merge cal test /cr/

Mike Leffel to: Nick Lalic

10/07/2015 02:58 PM

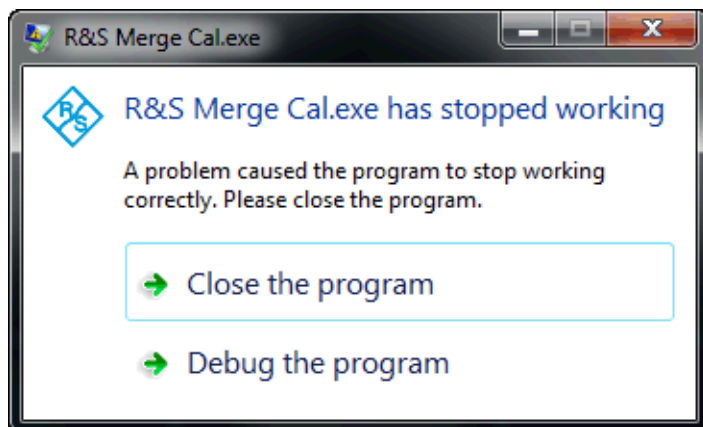
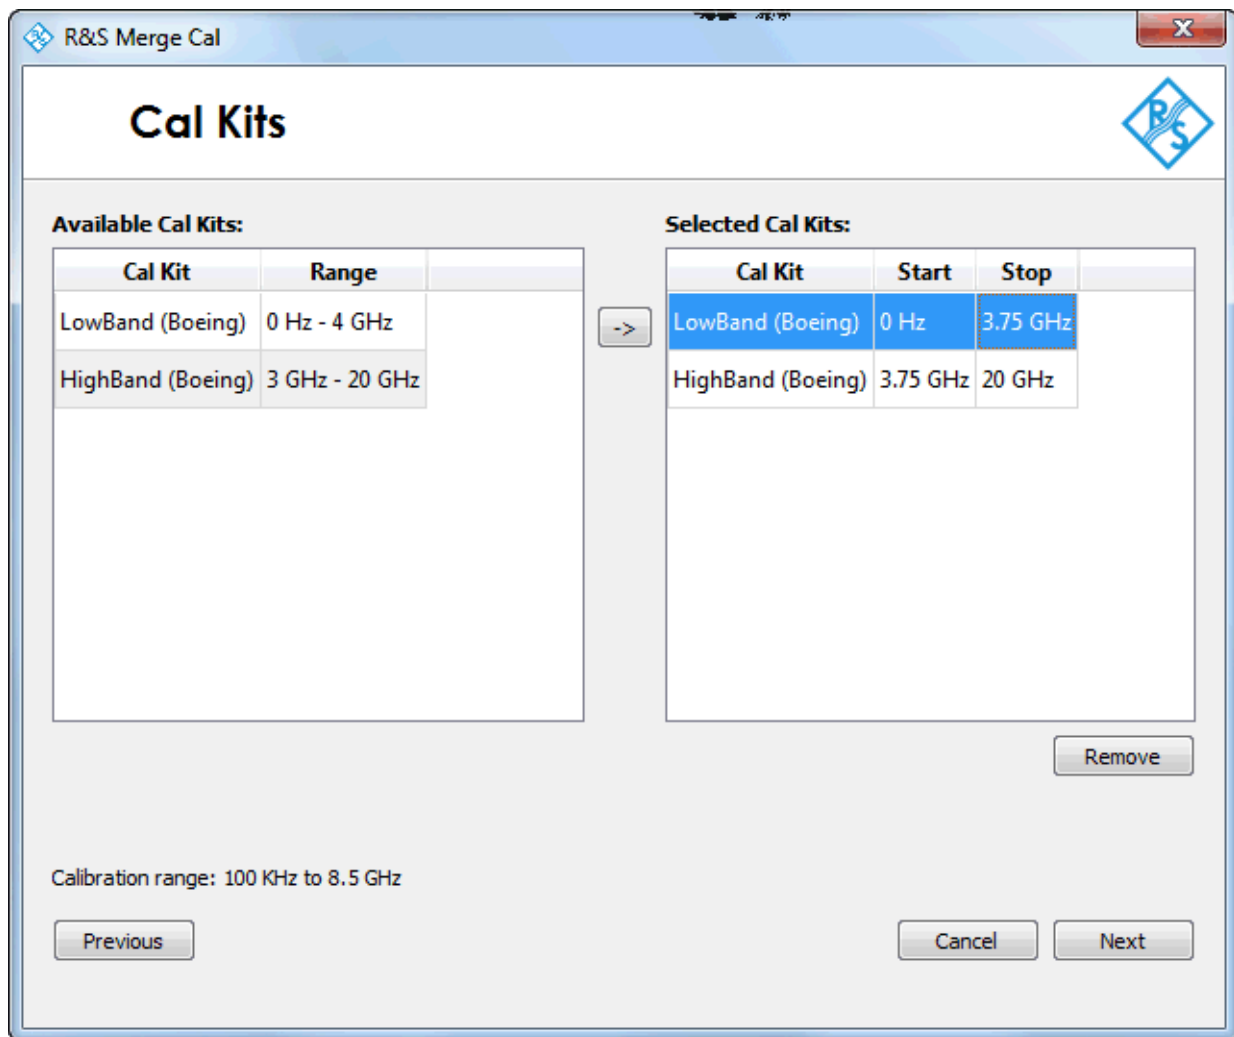
The results look good, and your results compare pretty well to the internal calibration. Close enough that I

can not tell if there is an error, or if the difference is due to cable movement and connector repeatability.

That is a good thing... But I wonder if the error message below in #2 is causing a small error.

Also to remove all doubt, it would be good for us to audit the "temp" cal kit files that you create to make sure every parameter is correct.

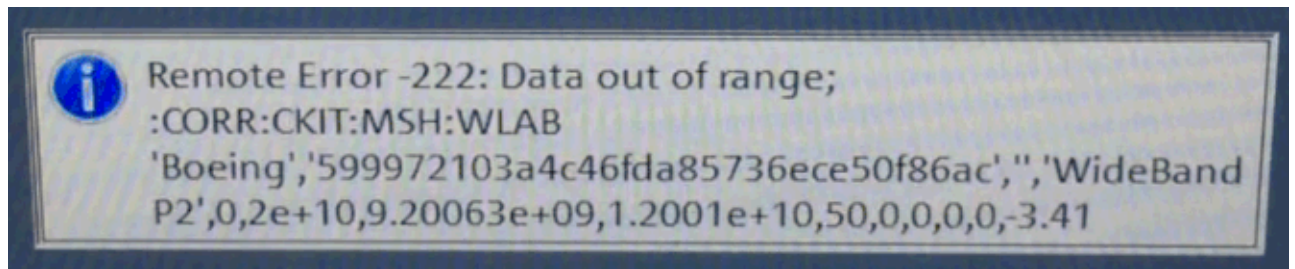
1. On this screen, if you click cancel or close the window, the application quits with an error message.

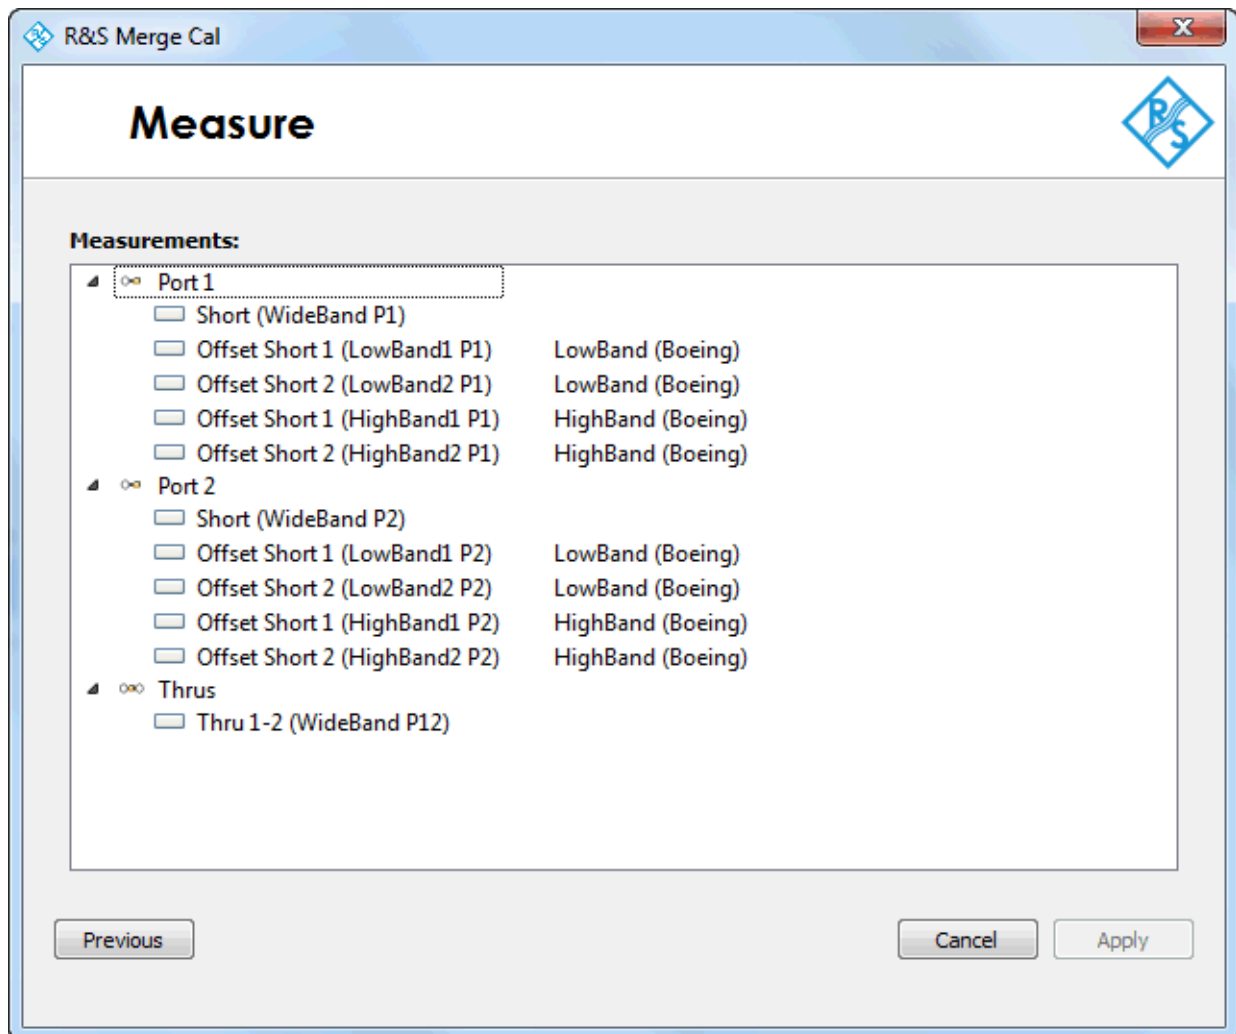
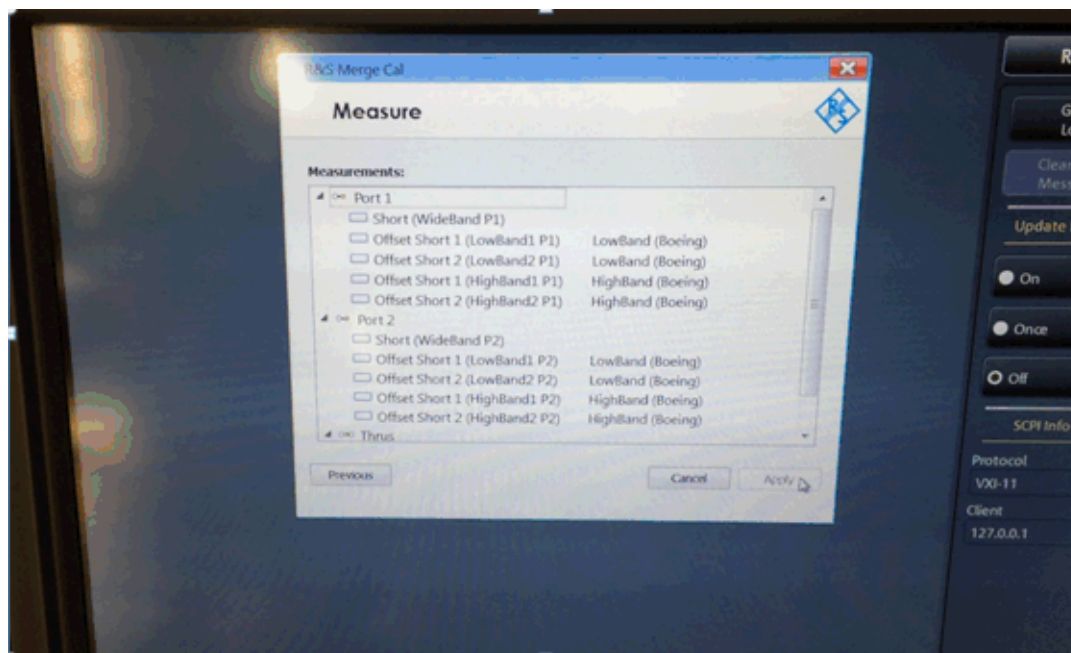
2. I see the error message zip by when I press next on the cal kits screen. But I am still able to calibrate.
